MONTGOMERY COUNTY HISTORIC PRESERVATION COMMISSION
STAFF REPORT

Address:	9 Primrose Street, Chevy Chase	Meeting Date:	3/11/2026
Resource:	Contributing Resource (Chevy Chase Village Historic District)	Report Date:	3/4/2026
Applicant:	Alice Keating Katie Scott, Agent	Public Notice:	2/25/2026
Review:	HAWP	Tax Credit:	Yes
Permit Number:	1146371	Staff:	Dan Bruechert
Proposal:	Railing Replacement

Figure 5: Areas of paint failure show substantial wood rot.

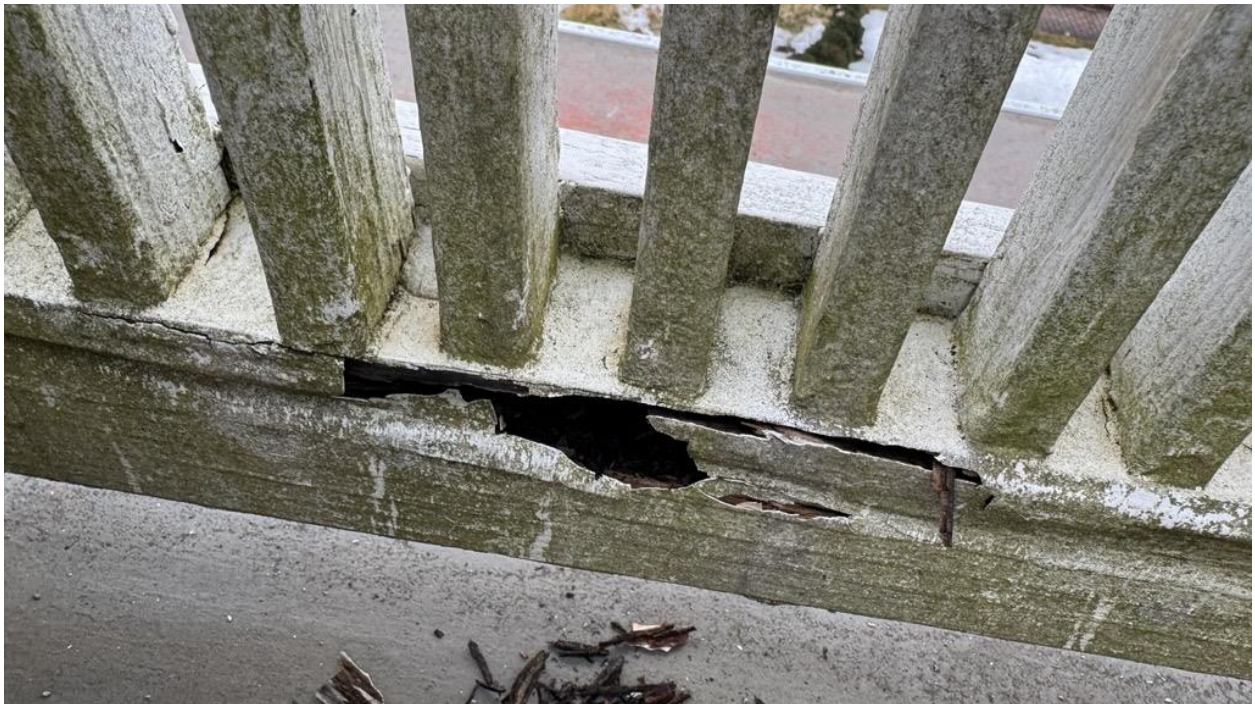
Furthermore, the railing will need to be removed to accommodate the new roof surface, approved by Staff in December 2025. Staff finds the railing has deteriorated to the point it will likely fall apart when it is removed for the new roof installation, and the railing has deteriorated beyond reasonable repair and must be replaced. Staff supports the railing removal under 24A-8(b)(2) and (d) and *Standard #6*.

In evaluating the existing railing, Staff has come to the conclusion that the existing railing is likely not the original second floor railing for several reasons. First, the two baluster dimensions do not match. Staff finds it would have been highly unlikely that two different railing designs were installed on a house with this high level of design and craftsmanship (see *Figs 4 and 5*, above and the application photos). Second, to accommodate the PVC-wrapped posts, the existing railing would have been removed (the PVC posts are highly visible in *Fig. 2*, above). The railing would likely have been replaced at this time. Third, because the house faces south, the second-floor porch is fully exposed to the sun, and as the house is over 120 years old, Staff finds the second-floor railing would have degraded much faster than the materials on the covered first floor porch. While none of these reasons are individually determinative, Staff finds it highly unlikely that the existing railing is constructed using the historic fabric and that it is just as unlikely that the historic railing design was retained. As Staff concludes the existing railing is not the original one, Staff finds it is not necessary to replicate the design and dimensions of the existing second-story porch railing.

1. The replacement railing must be constructed out of wood. A revised proposal showing a wood railing must be submitted to Staff before the issuance of the final HAWP approval documents.

Description: Custom rail with 1" x 1-3/4" slat balusters

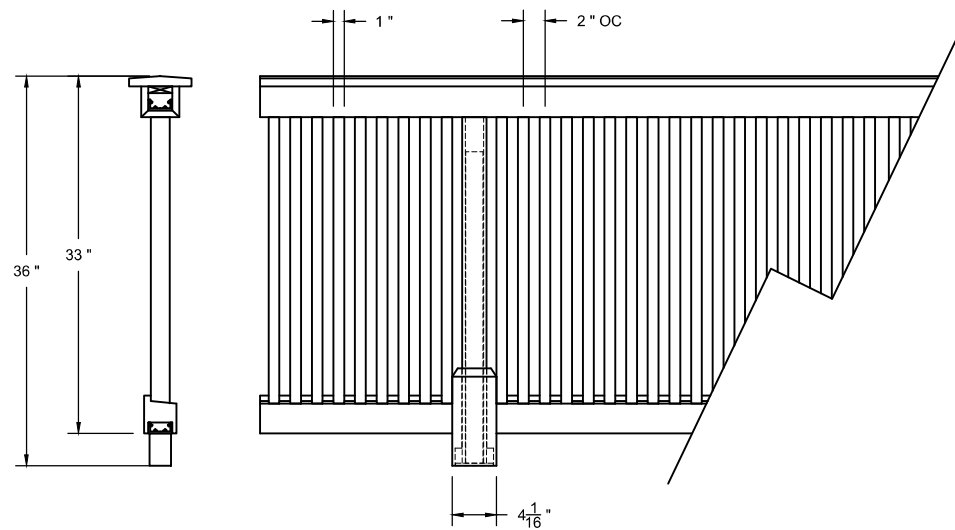
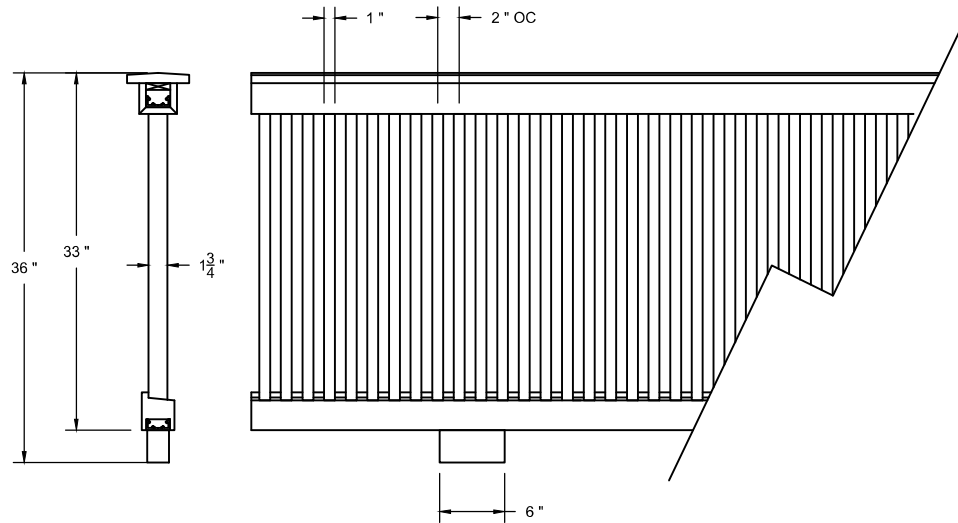
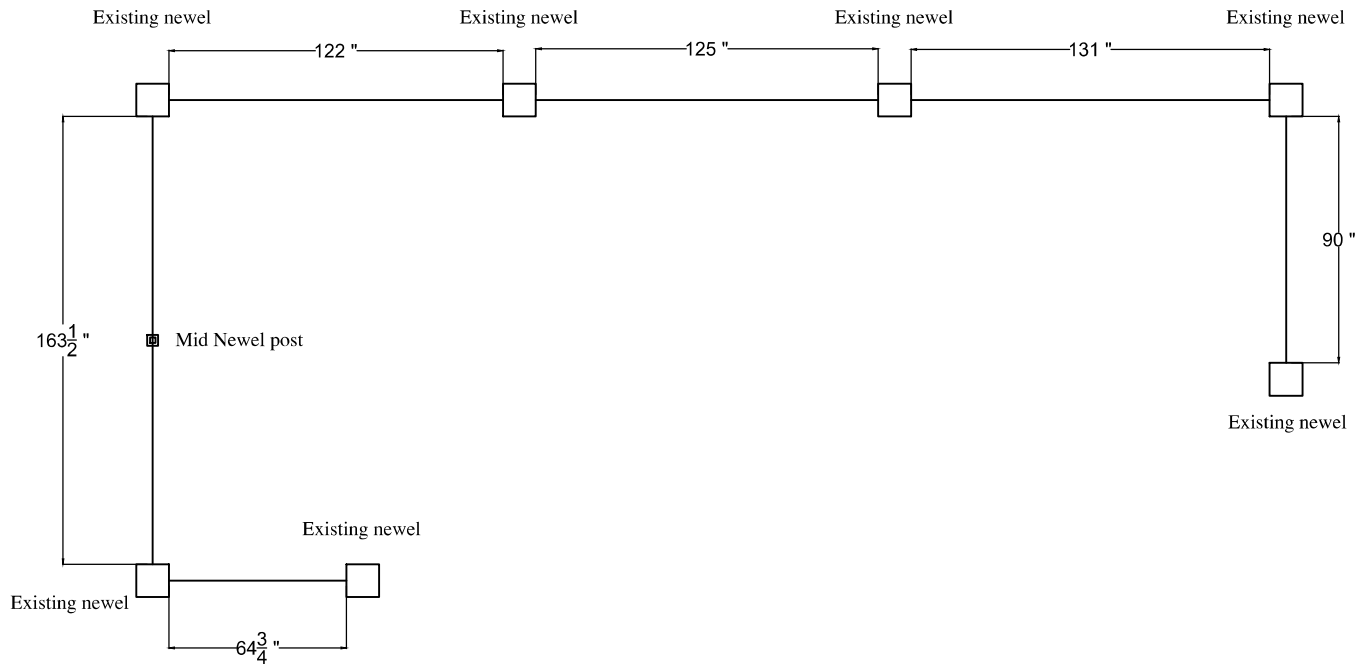
The applicant proposes to replace the railing with a custom milled Intex cellular PVC railing. The new railing will maintain the general appearance of the existing railing on the ground floor porch but differs in two dimensions. First, the railing height will be raised by 3" (three inches) to 36" (thirty-six inches) to satisfy existing building code. The second change to the design is the new balusters will measure 1" × 1 ¾" (one inch wide by one-and-three-quarters inch deep), 1/8" (one-eighth inch) wider than the existing baluster. This is the narrowest profile available from this manufacture. This railing system includes custom milled profiles to match the existing railing and is internally reinforced. All fasteners are hidden. The cellular PVC is paintable. The change in the railing height is intended to satisfy existing building code and staff supports this design change under 24A-8(b)(4) as the taller rail will remedy a potential hazard. Staff finds the proposed dimension changes are appropriate but finds that a wood railing is the appropriate material for the reasons outlined below.

While Staff finds the proposed design and dimensions to be appropriate, under the *Standards* and 24A, Staff does not find the proposed material to be appropriate and recommends the HPC add a condition to the approval of this project requiring the railing to be wood. The *Design Guidelines* require a moderate scrutiny review for the replacement railing for changes to porches visible from the public right-of-way. The plain language of *Standard #6* requires the replacement of historic features, when possible, with matching materials (the justification for allowing minor changes in the dimensions/design and not requiring an exact match is discussed above). Wood is a widely available product and can be milled to match the profiles and dimensions of the other members. To further investigate the appropriateness of substitute materials, Staff utilized the guidance in *Preservation Briefs #16: The use of Substitute Materials on Historic Exteriors*, a publication by the National Park Service providing general best

practices on historic preservation topics.¹ The brief provides several criteria to be applied when considering a substitute material. Among the criteria are, the availability of the historic material, the inadequacy of the durability of the available material, the significance of the feature being replaced, code-required performance, the closeness of the visual and physical match, and the material's performance over time. In balancing these factors, Staff finds that the wood can be milled to match and thoroughly painting the railing will offer substantial material protection; and that wood has the strength necessary to satisfy code. Additionally, Staff finds that the railing is in a prominent location on the front of the house. Staff further finds that the Intex cellular PVC will not develop a patina and replicate the appearance of the aged wood.

The application of moderate scrutiny as defined in the *Design Guidelines*, includes the consideration of 'compatible new materials.' The *Guidelines* fail to provide any additional information as to how to determine what factors make a material compatible. Staff therefore relies on the guidance in the *Preservation Brief* and again concludes that wood is the appropriate material.
